Alexandra Road shared use path audit

The purpose of this audit is to identify the work needed on this path to bring it up to standard. It draws on advice from John Meudell (a CTC Director, knowledgeable in these matters) who on a recent visit to Swansea drew attention to a number of shortcomings on this path.

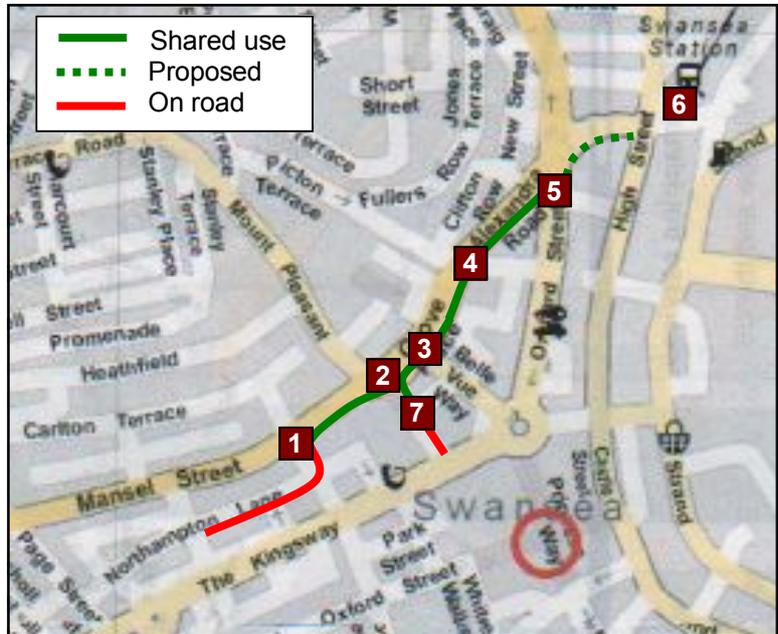
The heading numbers correspond to the numbers on both the plan and the photos.
